July 1, 1997

Subject: LaSalle County Nuclear Power Station Units 1 and 2
Application for Amendment of Facility Operating
Licenses NPF-11 and NPF-18, Appendix A, Technical
Specifications, changing the definition of Channel
Calibration and correcting miscellaneous errors in the
Technical Specifications and Bases.
NRC Docket Nos. 50-373 and 50-374

ATTACHMENT A
DESCRIPTION OF SAFETY ANALYSIS OF THE PROPOSED CHANGES

FIGURE 1
TRAVERSING IN-CORE PROBE SIMPLIFIED DIAGRAM

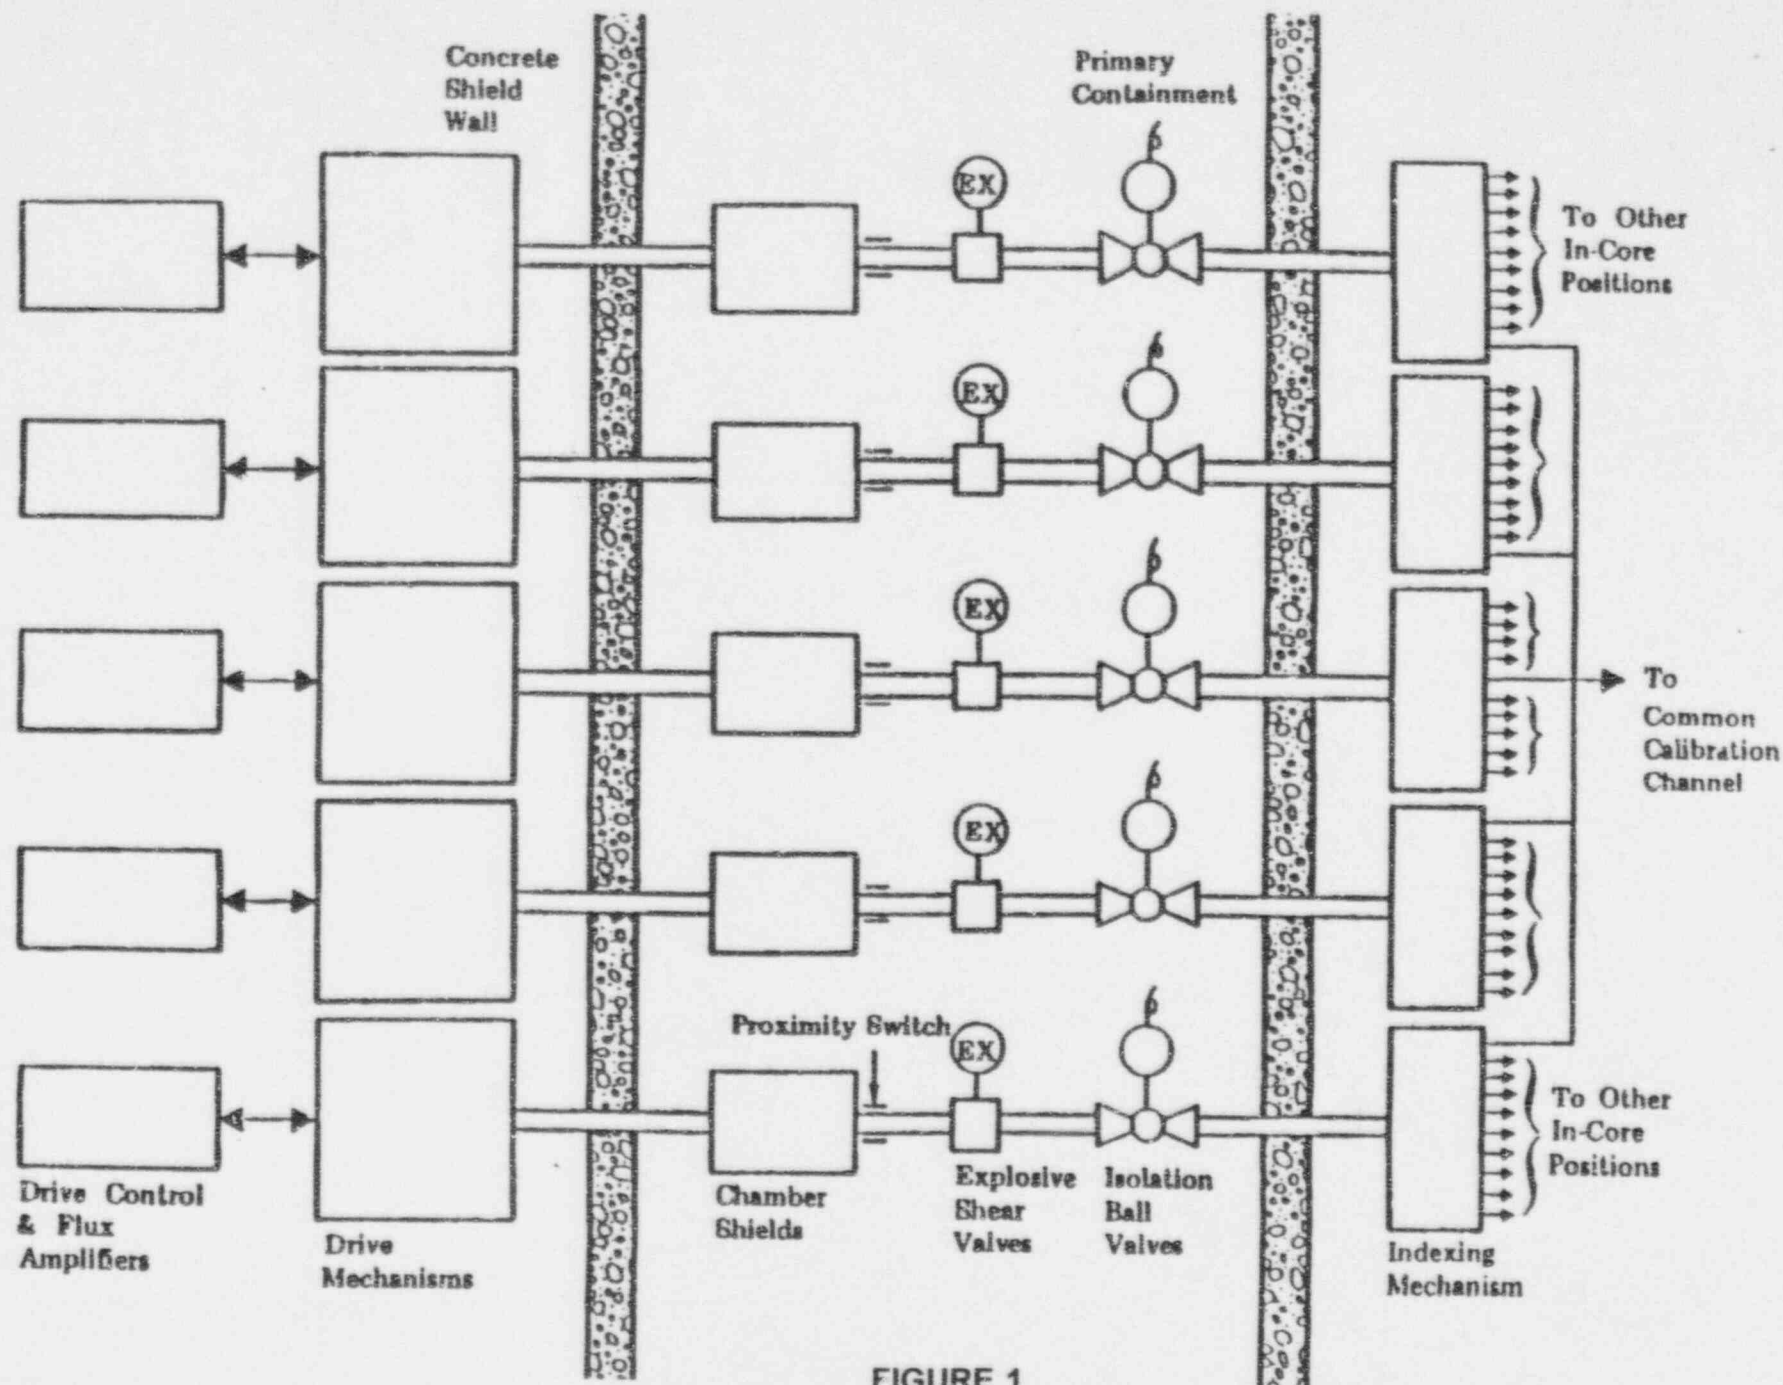
- b. TS Table 3.3.2-1 Isolation Actuation Instrumentation, item B.2, Outboard Valve isolation incorrectly lists isolation group 7 as receiving a containment manual isolation signal. Containment isolation group 7 only contains inboard automatic isolation valves for the Transversing In-core Probe (TIP) system. Group 7 is proposed to be removed from the outboard manual isolation function, since there are no automatic outboard isolation valves for the TIP system.

- b. TS Table 3.3.2-1, Isolation Actuation Instrumentation, includes Manual Initiations. The isolation valve group 7 is for the automatic TIP isolation valves, which are only inboard isolation valves. The valve groups operated by signal column for B.2 includes "1, 2, 5, 6, 7". It should not include group 7.

- b. Primary containment isolation valve group 7, TIP system isolation has two valves outside of the primary containment for each of five penetrations. The inboard isolation is an automatic isolation valve that automatically closes on an inboard isolation of the primary containment due to trip functions A.1.a.(1), reactor vessel water level low, level 3; A.1.b, drywell pressure - high. In addition, Group 7 valves close on a manual initiation of the inboard valves, as required by B.1.

The outboard isolation valves for the TIP system penetrations are explosive squib valves. If a TIP system probe(s) is inserted past the inboard isolation valve(s) and will not withdraw to allow closure of the associated ball valve(s) when a valid isolation actuation signal is received, procedures require manually actuating the associated TIP system explosive squib valve(s) to shear the respective TIP cable and isolate the line. The explosive squib valves are controlled using a keylock switch in the main control room and are required to be operable by TS 3.6.3 and verified operable per TS SR 4.6.3.5 on a periodic basis. These valves are not actuated from the primary containment manual isolation logic due to the nature of the TIP system. Therefore, group 7, TIP system outboard valves, is proposed to be deleted from TS Table 3.3.2-1, Functional Unit B.2. For information, a simplified diagram of the TIP system component arrangement is included as Figure 1 at the end of this attachment.

- b. TS Table 3.3.2-1, Trip Function B.2, valve groups operated by the manual isolation signal is proposed to be changed to delete TIP isolation valves group 7 from the list.
- c. Note (e) is proposed to be deleted from Trip Function 4.a in TS Table 3.3.6-1.
- d. Note # is proposed to be corrected to be Note ## in the last paragraph on Bases page B 3/4 3-1.
